Manual Update

Document Title: TMS380 Adapter Chipset User's Guide
TMS380 Adapter Chipset User's Guide Supplement

Document Number: SPWU001D, SPWU003

This document updates the TMS380 Adapter Chipset User's Guide, Revision D, document number SPWU001D, dated July 1986, and the TMS380 Adapter Chipset User's Guide Supplement (which includes Revision E), document number SPWU003, dated August 1987.

3-14

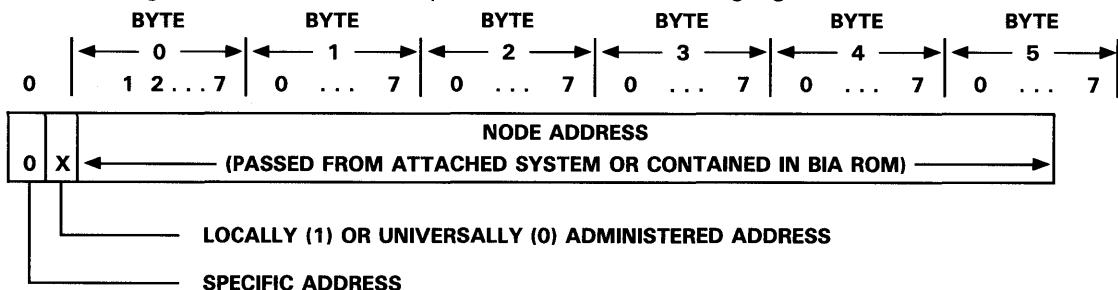
3-14	The last paragraph on this page should be changed to read as follows: A ring station address assigned by the attached system or contained in the BIA ROM must conform to the format shown in Figure 3-14. Note that bit 0 of byte 0 must be set to zero. Bit 1 of byte 0 may be set to either 0 or 1 when the TMS38021 Protocol Handler is used but must be set to 1 when the TMS38020 Protocol Handler is used. Violating these conditions causes the Adapter to reject the address assignment with a node address error.
------	---

Figure 3-14 should be replaced with the following figure:

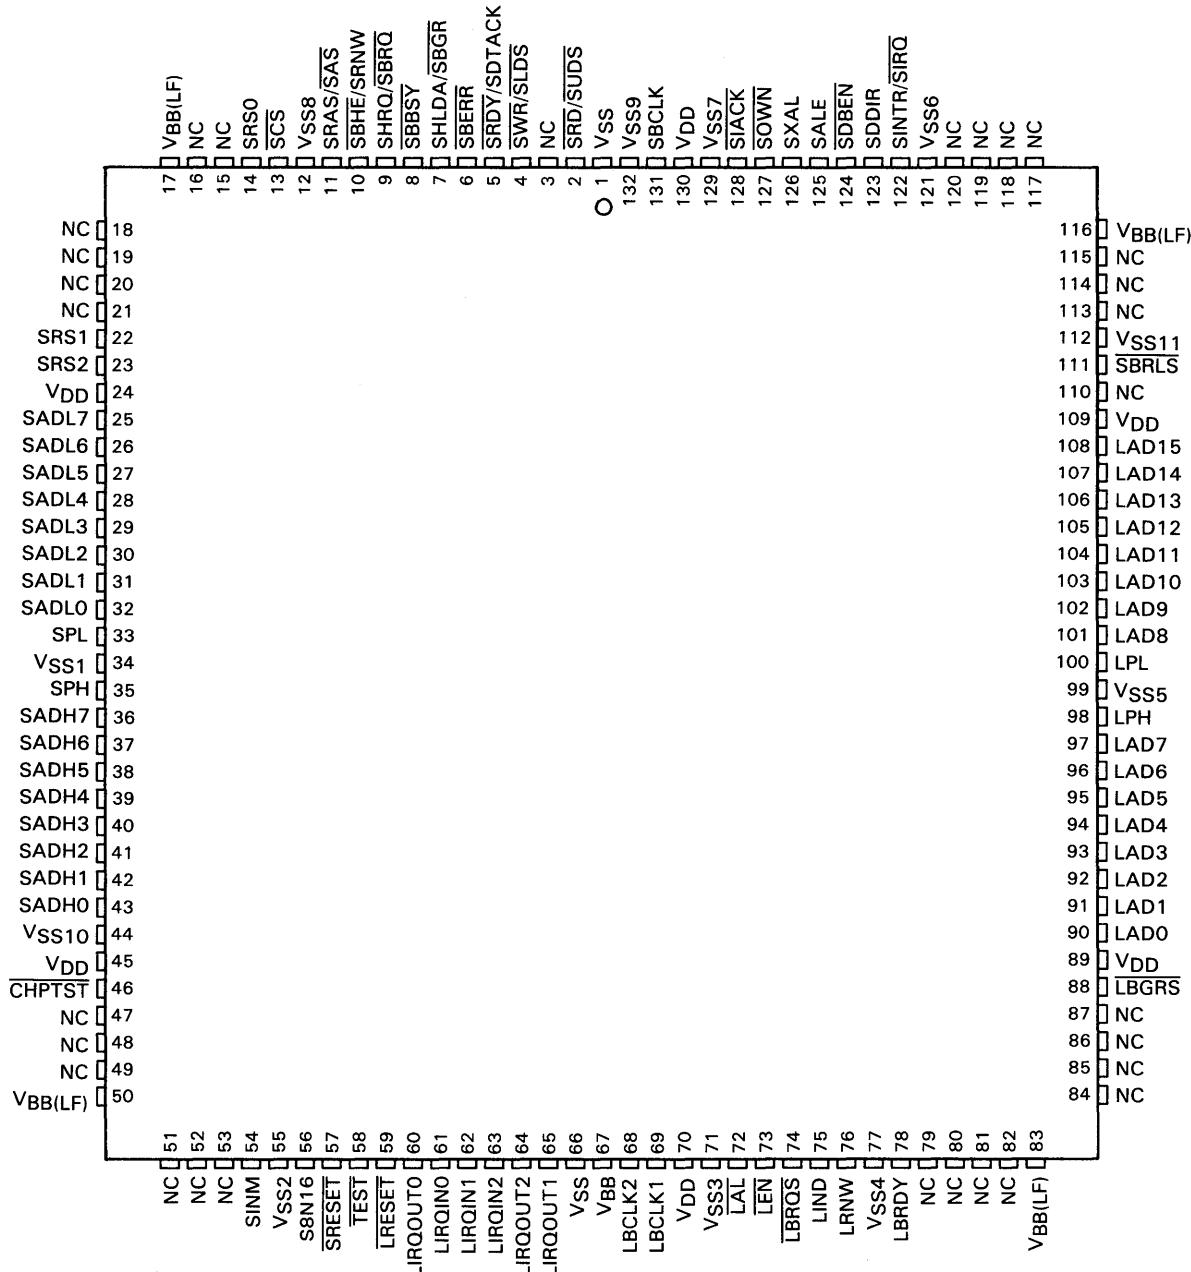
Add the following pinout drawing:

Special Note: The user PC board design should include a connection from the VBB pin (67) to one of the VBB(LF) pins (17, 50, 83, 116). This connection should be as short as possible. The VBB(LF) pins should be unconnected.

FIGURE 15. PROPAGATION DELAYS FROM DCLKIN TO RCVR WITH INTERNAL WRAP MODE

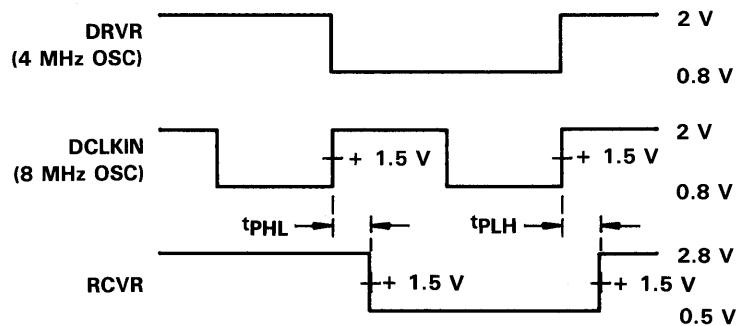
Figure 15 should be replaced with the following:

FIGURE 16. SKEW AND ASYMMETRY FROM DCLKIN TO DROUTA AND DROUTB

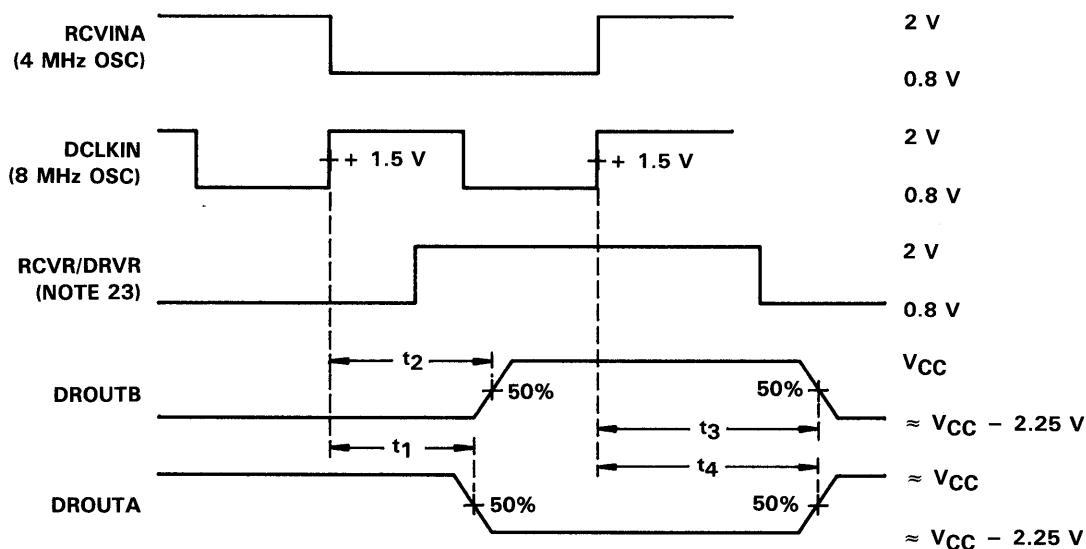
Figure 16 should be replaced with the following:

Note 23: For this test the RCVR output is tied directly to the DRVRR input to test the asymmetry of the transmitter in a repeater configuration.

**FIGURE B-1. BURNED-IN ADDRESS FORMAT**

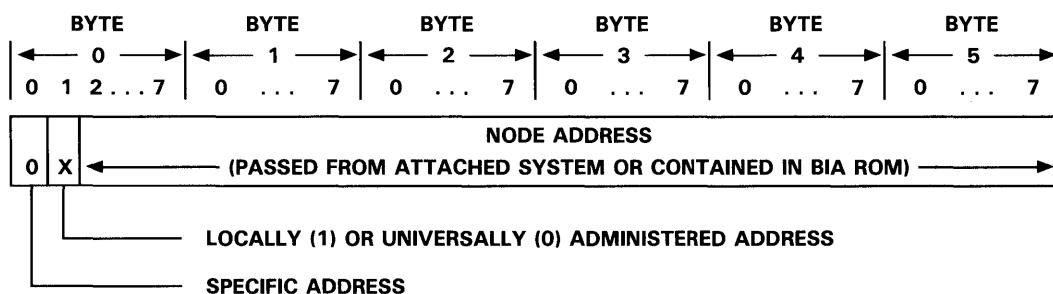
B-8 Replace Figure B-1 with the following:

The burned-in address must conform to that shown in the figure below. Note that bit 0 must be set to zero. If the TMS38020 Protocol Handler is used, bit 1 must also be set to zero.

B.3.3.5 132-Pin Plastic Quad Flat Package (PQ Suffix)

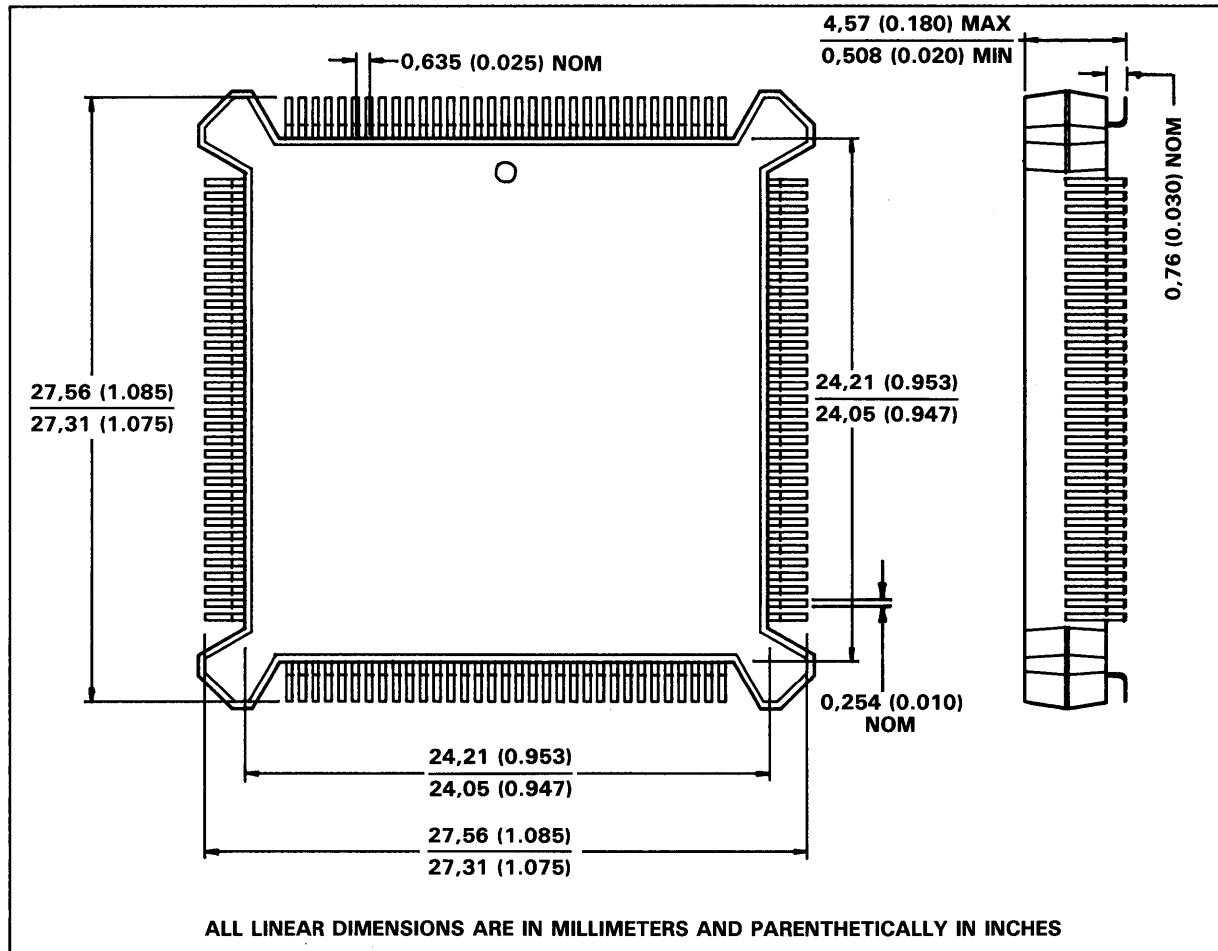
B-19 Add the following mechanical drawings:

FIGURE 2-5. TMS380 INTERFACE TO IBM PC AT SYSTEM BUS

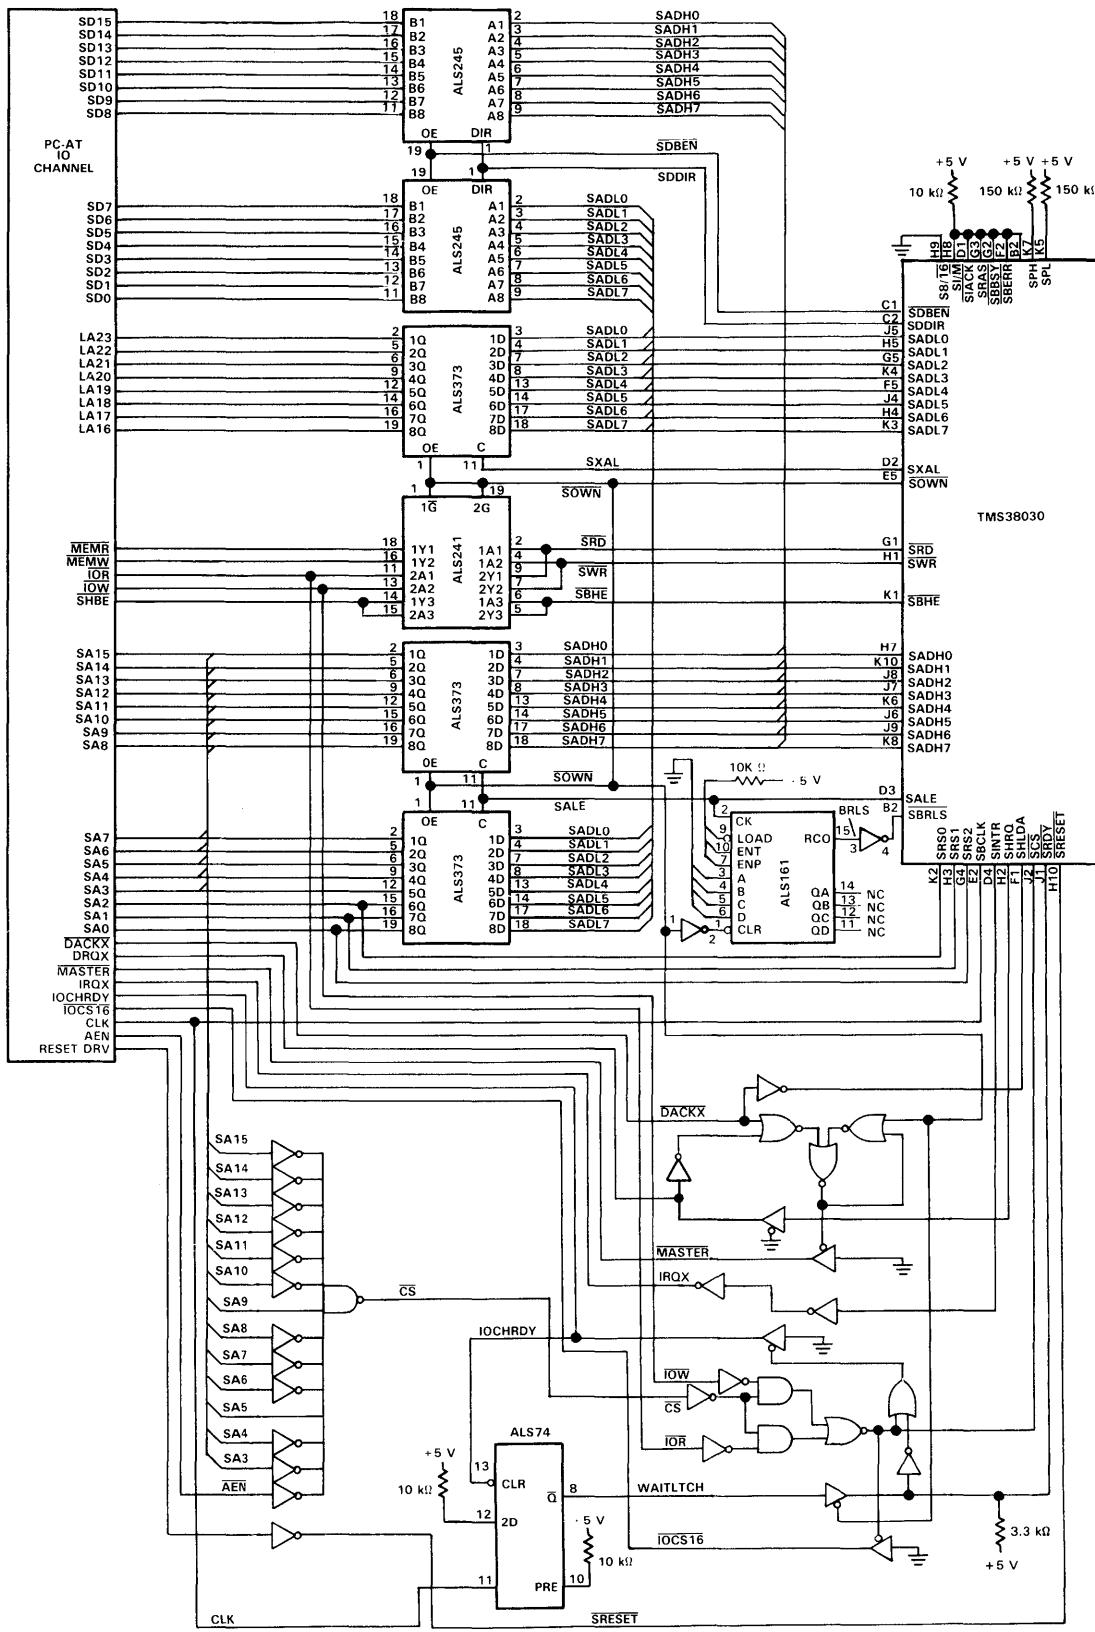
<u>Page</u>	<u>Change or Add</u>
2-9	Section 2.4, PC AT Adapter Card Example. The schematic supports standard 6-MHz PC AT buses. For higher-speed buses, when the TMS380 is in 16-bit mode, 8-bit DIO using SBHE and AO should be used. This is to avoid timing problems with IOCHRDY for wait state generation.
2-11	Figure 2-5 should be replaced with the new Figure 2-5 on page 12 of this manual update.
3-8	Add the following paragraph to the bottom of section 3.4.2. Also shown in Figure 3-3 is a structure called an abort delimiter. The abort delimiter consists of a Starting Delimiter and Ending Delimiter sequence. The abort delimiter is transmitted by the TMS380 Adapter whenever the Adapter detects a 'false free token' as described in Section 3.10.2.
3-8	Add the following to Figure 3-3.

FIGURE 4-5. ADAPTER CHIPSET INTERCONNECT DIAGRAM (3 of 4)

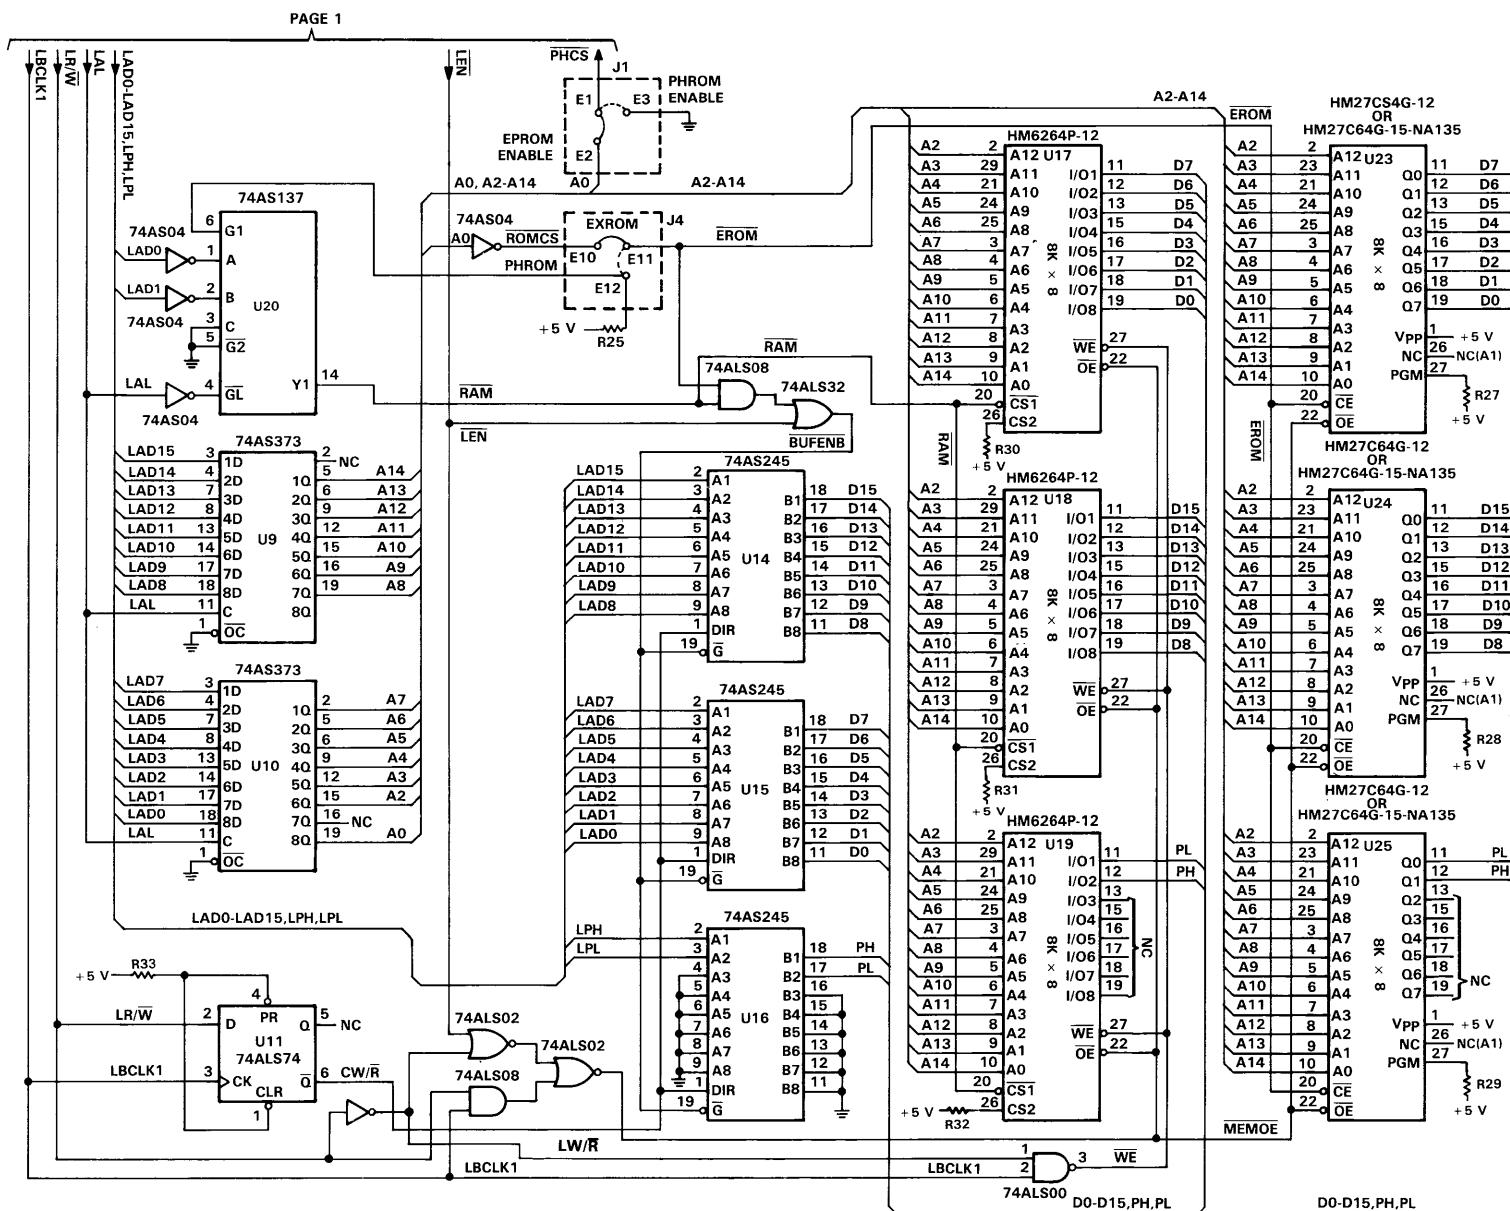
Figure 4-5, sheet 3 of the Adapter Chipset Interconnect Schematic should be replaced with the new sheet 3 on page 13 of this update.

Figure 4-5 sheet 4. The value for capacitor C3 should be changed to 22,000 pF ± 10%, and a Note 4 reference added. The following should be added to the bottom of the page as Note 4:

NOTE 4: For additional noise immunity, the value for C3 has been increased to 22,000 pF. For existing designs, the original 6,800 pF value may be used.

NOTE 4. For additional noise immunity, the value for C3 has been increased to 22,000 pF. For existing designs, the original 6,800 pF value may be used.

FIGURE 3-2. EPROM-Based Adapter Bus Schematic

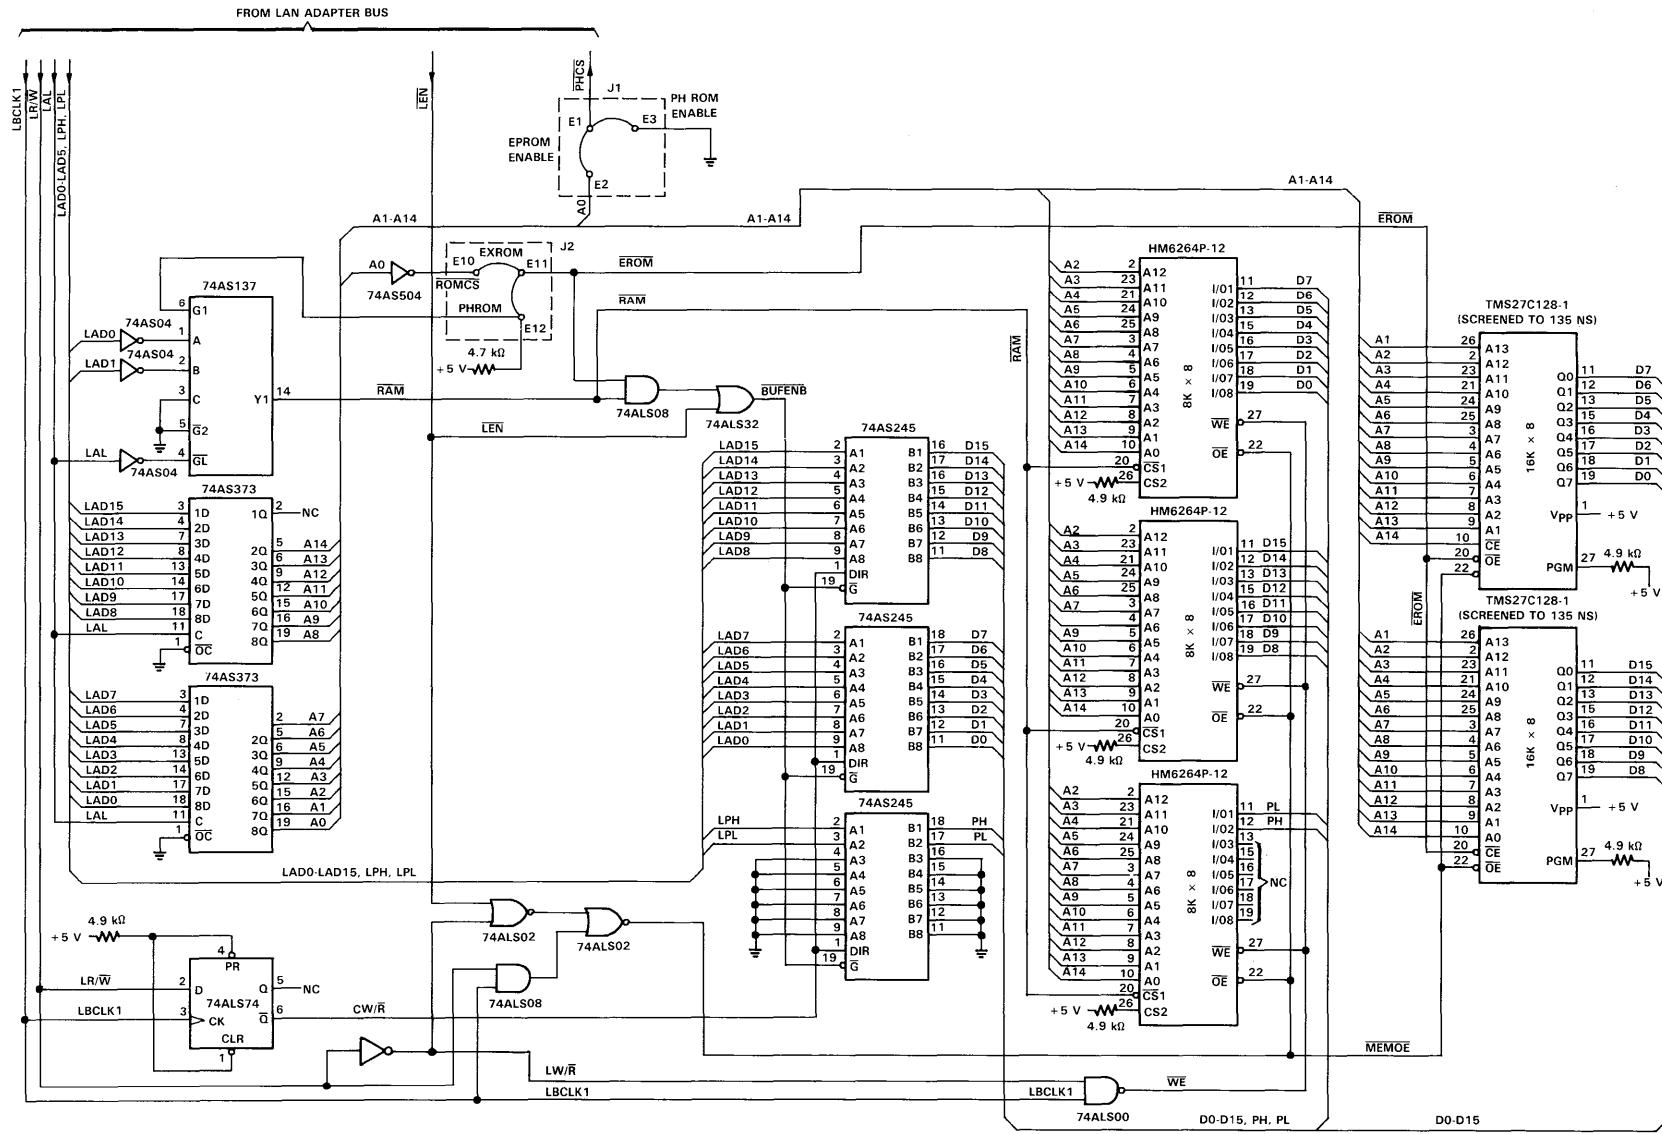
3-2 Figure 3-2 should be replaced with the new Figure 3-2 included on page 18 of this update.
